## NCINC Meeting Notes on Design of I-35

- **November 2, 2001 at TxDOT office Building #2 from 9:00 am to 11:30 am**

Phase I - Remove Center section to clear way for new HOV Lanes

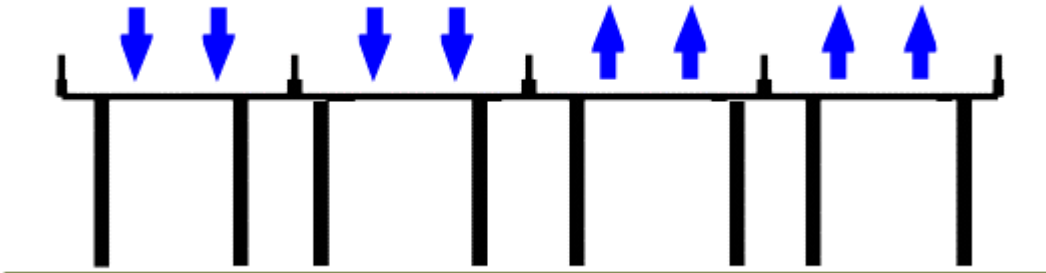
*In the illustration above, we questioned how can they remove enough of the center-most roadway to allow for the construction of the new HOV structure and still leave a usable portion of roadway for one lane of traffic (note how precariously the remaining lane is perched on that one remaining column).*

Phase I - Remove Center section to clear way for new HOV Lanes

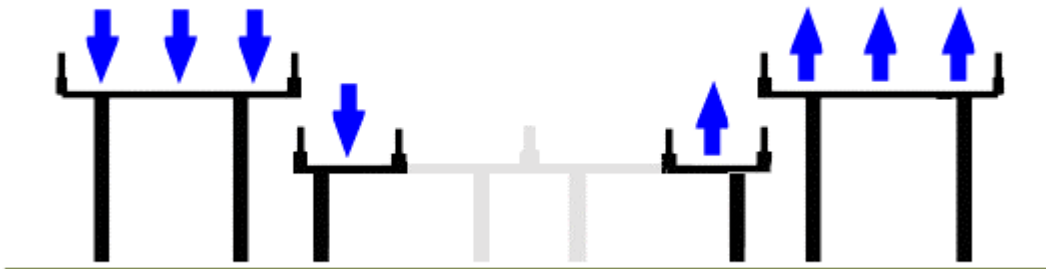
*In the illustration above, we questioned how can they remove enough of the center-most roadway to allow for the construction of the new HOV structure and still leave a usable portion of roadway for one lane of traffic (note how precariously the remaining lane is perched on that one remaining column).*
